## Application Review

<p style="text-align: center;"><b>Facility Data</b></p> <p><b>Applicant (Facility's Name):</b> Statesville Brick Company</p> <p><b>Facility Address:</b>          Statesville Brick Company          391 Brickyard Road          Statesville, NC 28687</p> <p><b>SIC:</b> 3251 / Brick And Structural Clay Tile  <b>NAICS:</b> 327121 / Brick and Structural Clay Tile Manufacturing</p> <p><b>Facility Classification: Before:</b> Title V <b>After:</b> Title V  <b>Fee Classification: Before:</b> Title V <b>After:</b> Title V</p>	<p style="text-align: center;"><b>Permit Applicability (this application only)</b></p> <p><b>SIP:</b> 15A NCAC 02D .0515, .0516, .0521, .1109, .1100, .1111, .1806, and 02Q .0711  <b>NSPS:</b> N/A  <b>NESHAP:</b> 02D .1111 for MACT Subpart JJJJ (effective December 28, 2023)  <b>PSD:</b> N/A  <b>PSD Avoidance:</b> N/A  <b>NC Toxics:</b> 15A NCAC 02D .1100 and 02Q .0711  <b>112(r):</b> N/A  <b>Other:</b> N/A</p>

**1. Purpose of Application**

Statesville Brick Company has submitted a renewal application, 4900070.20A, for their current Title V air permit, 02493T11. The facility is located at 391 Brickyard Road in Statesville, Iredell County, NC. The re

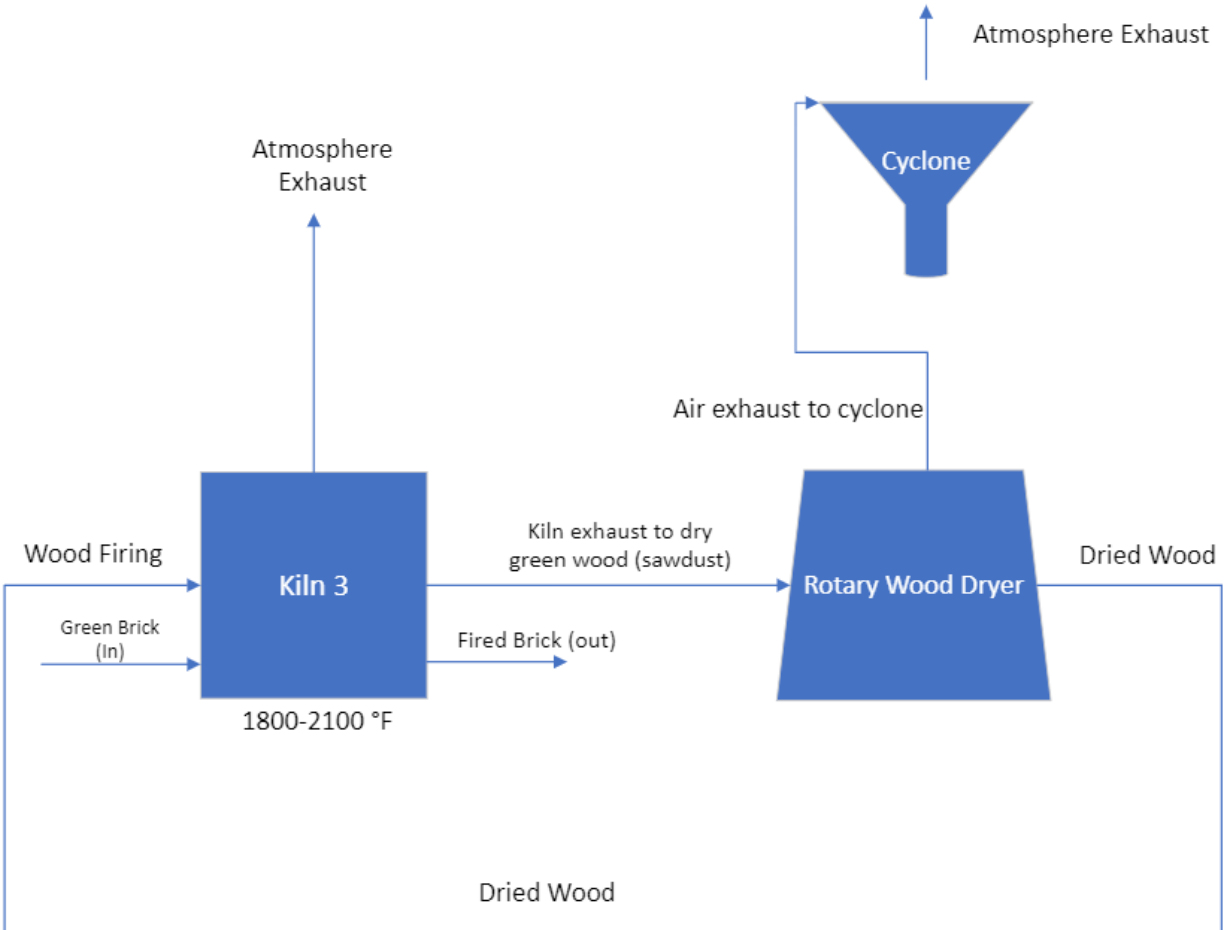
Please review the following diagram.

As you review the above diagram, you can see that the exhaust from the kiln goes two ways. A part of the exhaust is vented directly to the atmosphere and the remainder of the exhaust is sent to the rotary wood dryer (or sawdust dryer) where green wood is dried for fuel firing in the kiln. The exhaust from this wood dryer which originated in the kiln is then vented through a cyclone to the atmosphere.

**DAQ Response:** 40 CFR Part 63, Subpart JJJJ (63.8390(b)) specifies affected sources as “all tunnel kilns at a BSCP manufacturing facility”. 63.8515 defines tunnel kiln as “any continuous kiln that is used to fire BSCP” and continues to state that “some tunnel kilns have two process streams, including a process stream that exhausts directly to the atmosphere or to an APCD, and a process stream in which the kiln exhaust is ducted to a sawdust dryer where it is used to dry sawdust before being emitted to the atmosphere”. All kiln process streams, including the portion of a process stream that goes to a sawdust dryer, are subject to the emission limits in the MACT. However, the sawdust dryers themselves are not listed as affected sources.
